## Hydraulic Separators Need Help

### The Glitch

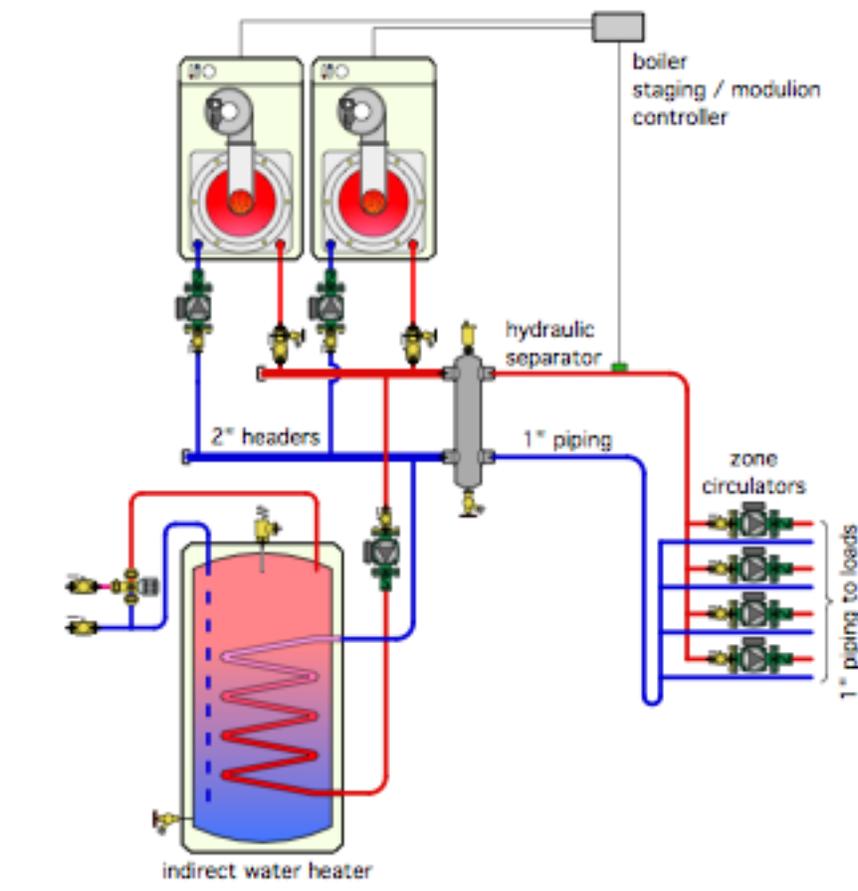
In order for a hydraulic separator to achieve its goal, headers leading to the individually pumped load circuits must be generously sized (design flow velocity of 2 ft. /sec or less). If not, a significant pressure drop can develop along the length of both the supply and return headers. This pressure drop will cause some interference among the zone circulators. It's not the fault of the hydraulic separator, but rather the headers connected to it. This is also true on the boiler side of the separator.

When the header is generously sized there is no need for reverse return piping. The latter is appropriate when the same circulator supplies flow through several parallel piping circuits having similar flow requirements. This is *not* the way this system is configured. Why waste piping when it's unnecessary?

Another problem involves the indirect tank connected on the boiler side of the hydraulic separator. In this arrangement, the sensor for the multiple-boiler controller is not getting a good indication of the water temperature going to the load during the prioritized domestic water heating mode, and thus cannot control it properly. This has been corrected by moving the connections for the indirect tank downstream of the supply temperature sensor.

The coil heat exchanger inside the indirect water heater is also piped backwards. Hot water from the boilers should always enter the top of the coil to create counterflow heat exchange within the tank.

Other errors / omissions include:

1. Lack of purging valves on the zone circuits and indirect circuit.
2. Circulators piped too close to the header (and thus receiving turbulent flow into the impeller). There should be at least 12 times the pipe diameter of straight piping leading into circulators.
